## SERVICE No. 161A BULLETIN

Piper Aircraft Corporation

SUBJECT: Fire Hazard

MODELS AFFECTED: All PA-16, PA-20 and PA-22 Airplanes, serial numbers 22-1 to 22-6194 inclusive

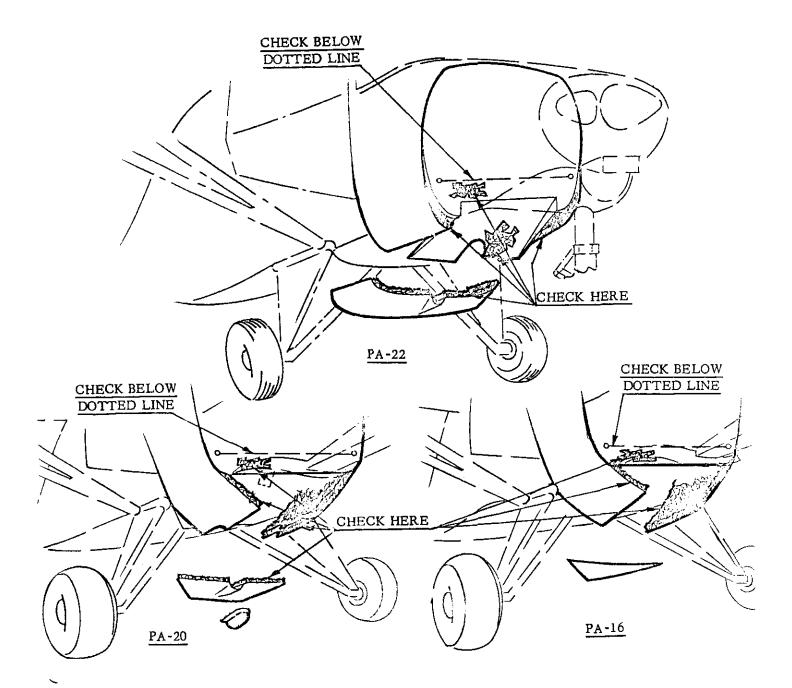
To preclude the possibility of in-flight fires, the following inspection and rework is necessary to eliminate combustible material and possible ignition sources from the area aft of the firewall underneath the forward cabin floor. Access to this section may be gained by removing the metal panels or opening the fuselage side cowl panels rearward of the firewall underneath the aircraft as shown in sketches on reverse side.

Remove and/or open panels as above. Remove and discard any soundproofing material contaminated with engine or hydraulic oil or any sound-proofing which has the plastic septum separated from the fiberglas or showing signs of drying or cracking. Replacement of a discarded blanket may be made with equivalent fiberglas. Inspect for chafing of wire insulation and replace any inferior electrical wiring. Check for reasonable clearance between hydraulic lines, electrical wires, control cables and fuel lines and provide clearance if necessary.

3. Upon completion of the above, apply a sufficient quantity of B. F. Goodrich nonhardening putty No. 21 or other acceptable aircraft materials between firewall and fuselage cowl blanket to assure an airtight seal when reassembling the opened and removed panels. Non-hardening sealing material is available through your distributor or local aviation supply house. Service Bulletin No. 161A
